REMARKS

Claims 1-33 were presented for examination and were pending in this application. In an Office Action dated December 21, 2004, Claim 12 was objected to as allowable if rewritten in independent form, and Claims 1-11 and 13-33 were rejected. Applicant thanks Examiner for Allowance of Claim 12. Applicant also thanks Examiner for examination of the claims pending in this application and addresses Examiner's comments below.

FIG. 2

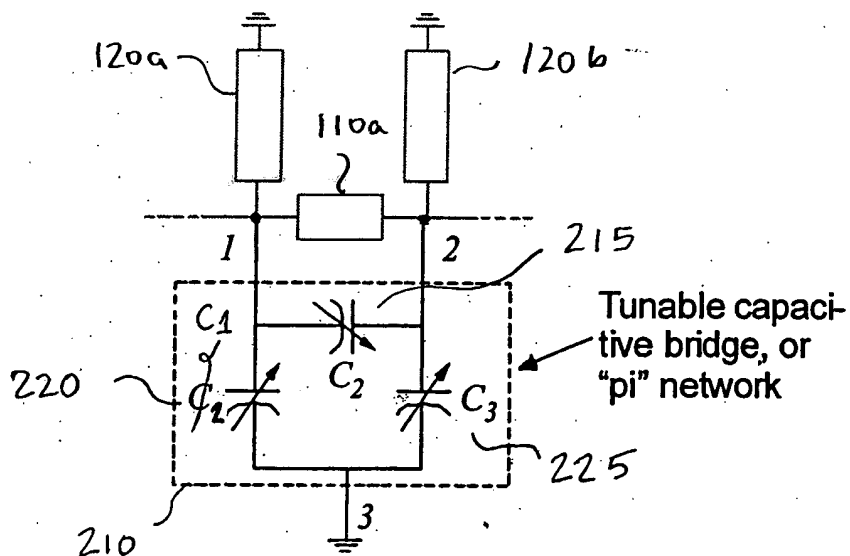
The Examiner objected to FIG. 2, stating, “[t]he drawings are objected to because first tunable variable capacitor ‘C₁’ (page 8, paragraph [0028]) is not shown on the drawing.”

Applicant has amended FIG. 2 to properly identify first tunable variable capacitor C₁. Applicant has also amended paragraphs [0028] and [0029] to properly reference capacitors C₁ and C₂ in FIG. 2. No new matter is introduced as a result of the amendments.

FIG. 4

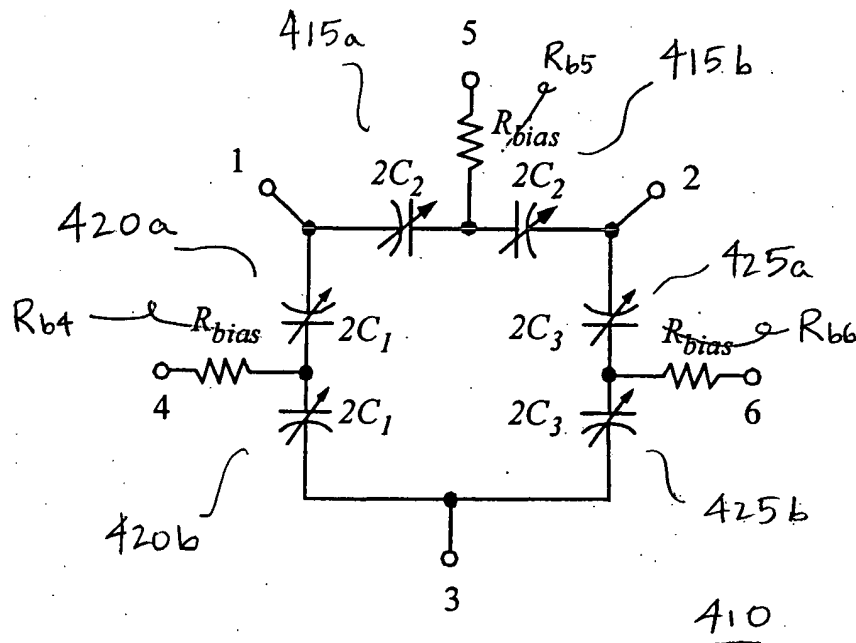
Applicant has amended FIGS. 4-6 to properly identify bias resistances R_{b4}, R_{b5}, and R_{b6}, as referenced in the specification, particularly paragraphs [0037] to [0039] and paragraph [0042]. No new matter is introduced as a result of the amendments.
